Proposed Revisions to a Standard Plans Index

Index Number: 700-011

Index Title: Single Column Cantilever Ground Mounted Sign

Summary of the changes:

TYPICAL SECTION

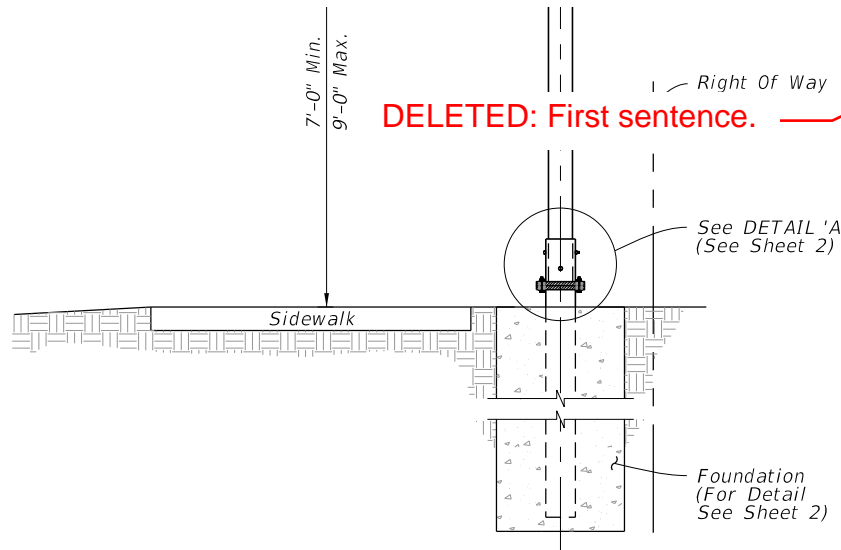
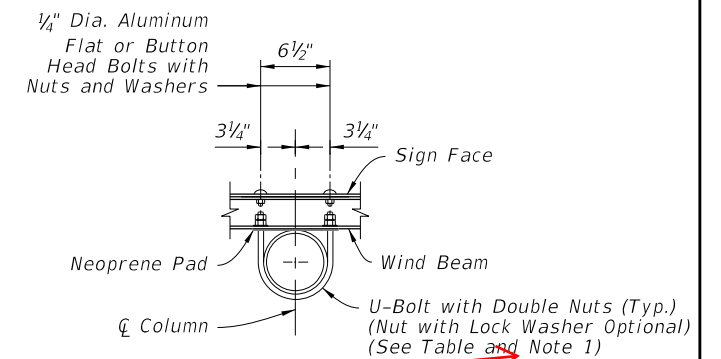
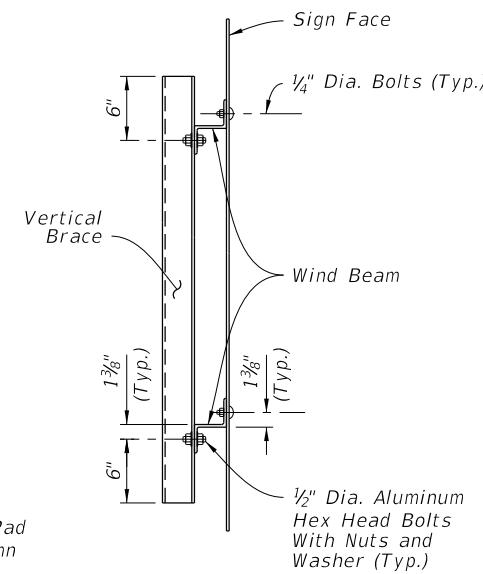
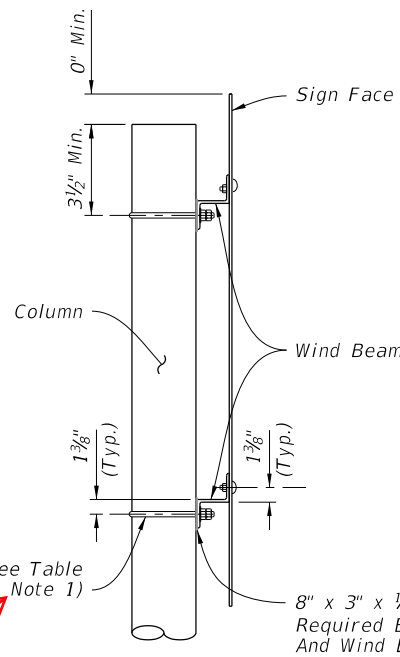
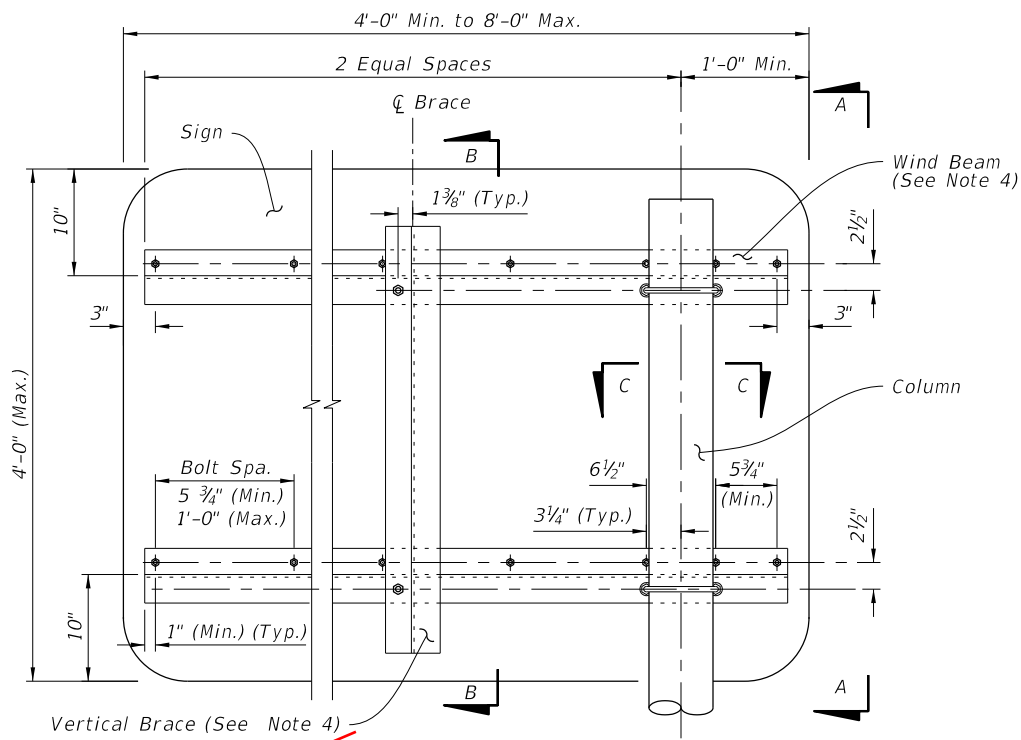
GENERAL COMMENT: Material information was deleted. Information is either already covered in Standard Specifications OR will be added to Section 700, 962 or 965 in conjunction with these revisions.

UPDATED NOTE 1:
Work with Index 700-010 for additional notes and the assembly of base connection.

NEW NOTE 2:
Meet the requirements of Specification 700.

DELETED: First sentence.

UPDATED: See General Note...

SIGN DETAIL

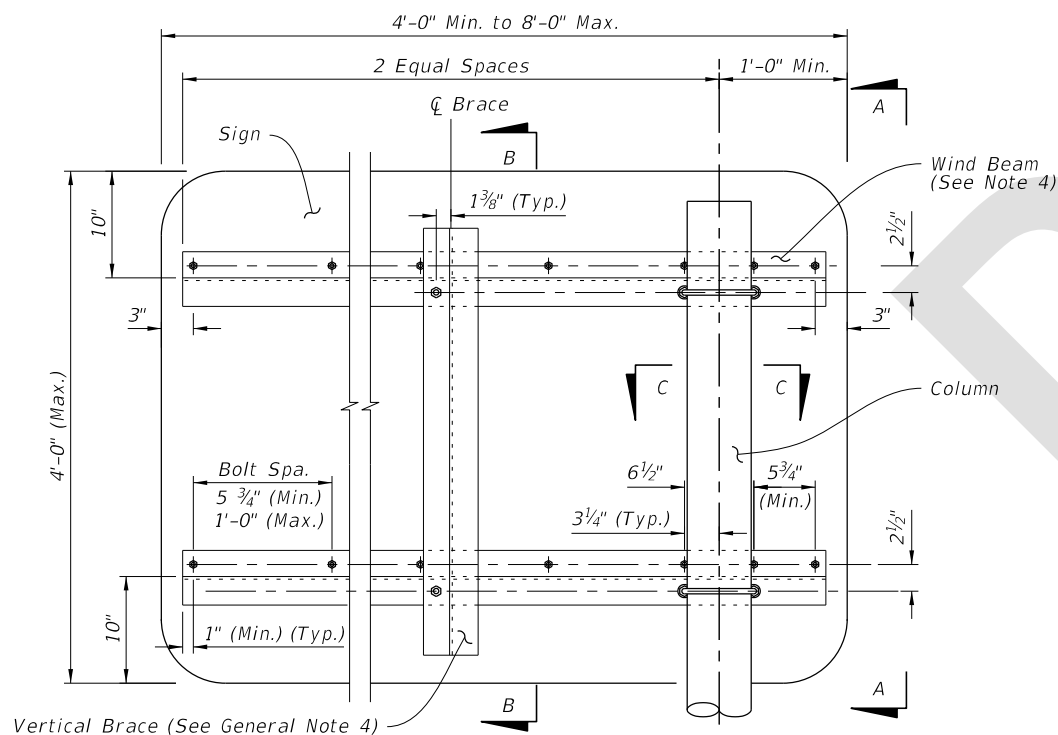
Updated General Note references in the SIGN DETAIL, VIEW A-A, SECTION B-B, and SECTION C-C.
